**INQUIRY INTO CURRENT AND POTENTIAL IMPACTS OF
GOLD, SILVER, LEAD AND ZINC MINING ON HUMAN
HEALTH, LAND, AIR AND WATER QUALITY IN NEW
SOUTH WALES**

**Written Submission to Portfolio Committee No. 2, Health, on the inquiry into
'Current and potential impacts of gold, silver, lead and zinc mining on human health, land, air
and water quality in New South Wales'**

My comments I hope to be general and pertinent but they are notably derived from my experiences in objecting to a proposed Silver, Lead and Zinc mine at a site some 20 kilometres from Rylstone at the village and locality called Lue. Referred to in the attached submission it is 'Bowdens'. (Proposal : Bowdens Silver Mine proposal, SSD 5765).

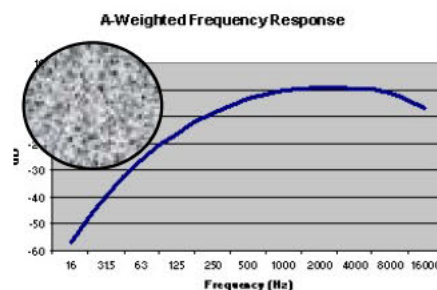
"Since A-weighting underestimates the sound pressure level of noise with low frequency components, a better assessment of health effects would be to use C-weighting", and

"It should be noted that a large proportion of low frequency components in a noise may increase considerably the adverse effects on health"

The curve shows dB(A) response and recording. Low frequency noise (that made by mining equipment) is shown as the circle. DPE and the proponent only use dB(A) because IT DOES NOT RECORD OR REPORT OR PREDICT LOW FREQUENCY (MINING) SOUNDS. They hide the reality.
